#9587 B4 SUPPLEMENTARY SHEET

For the RC10B4

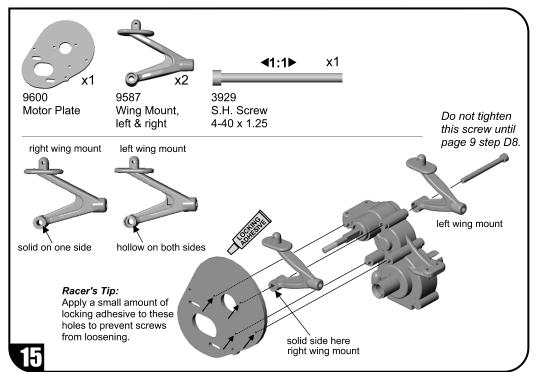
See instruction manual, page 7, step 15. We have modified one of the wing mounts for better durability. Please note that there are now left and right wing mounts. The left wing mount has hollows in both sides while the right wing mount is hollow on one side. Assemble them as shown here.
